Access Compliance Report

Public Rights-of-Way

(Curb Ramps)

Intersection ID: 12869	Main Street: E_TRADE_ST	Cross Street: N_ALEXANDER_ST	Location: W
ADA ID: FB3A5870033F	Ramp Type: PerpDiag	Initial Pass/Fail: Fail	Overall Compliance: No
Severity Score: 21.25			
Codes/Mitigation Info/Possible Solution		Field Measurements/Component Compliance

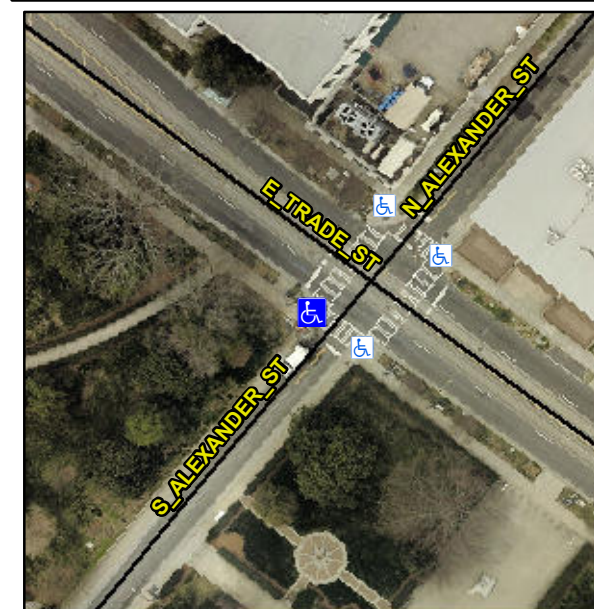
Not Found, R304.5.1, R304.5.3

Compliance	Description	Data	Compliance	Description	Data
N/A	Ramp Length (in)	66.0	Yes	Ramp Slope (%)	6.7
No	Ramp Width (in)	46.5	No	Ramp XSlope (%)	5.7
N/A	Flare Type LT	N/A	N/A	Flare Type RT	N/A
N/A	Flare Slope LT (%)	N/A	N/A	Flare Slope RT (%)	N/A
N/A	Flare Traversable LT?	N/A	N/A	Flare Traversable RT?	N/A
N/A	Landing Length (in)	N/A	N/A	DWS Provided?	N/A
N/A	Landing Width (in)	N/A	N/A	DWS Contrast?	N/A
N/A	Landing Slope (%)	N/A	N/A	DWS Length (in)	N/A
N/A	Landing X Slope (%)	N/A	N/A	DWS Full Width?	N/A
N/A	Landing Curb? (Y/N)	N/A	N/A	DWS Offset (in)	N/A
N/A	Shared Landing?	N/A			
N/A	Gutter Ponding?	N/A	N/A	Gutter Slope (%)	N/A
N/A	Gutter Lip Ht (in)	N/A	N/A	Gutter X Slope (%)	N/A
N/A	Painted X Walk1?	Yes	N/A	Painted X Walk2?	Yes
	X Walk 1 Direction	To SE		X Walk 2 Direction	To NE
N/A	X Walk 1 Width (in)	108.0	N/A	X Walk 2 Width (in)	112.0
	X Walk 1 Slope (%)	2.4		X Walk 2 Slope (%)	4.3
	X Walk 1 X Slope (%)	4.4		X Walk 2 X Slope (%)	1.1

N/A	Ramp inside XWalk1?	Yes	N/A	Ramp inside XWalk2?	Yes
	Road Slope (%)	4.6	N/A	Clear Space?	N/A
	Road X Slope (%)	2.6	N/A	Clear Space to XWalk (in)	N/A
N/A	Any Obstructions?	N/A	N/A	Storm Grate/Utility Hazard?	N/A
	Obstruction Type			Storm Grate/Utility Type	
		N/A			N/A
		Yes		Surface Condition? (G/P)	Good

Remove & Replace Curb Ramp With Two New Directional Ramps or Equivalent.
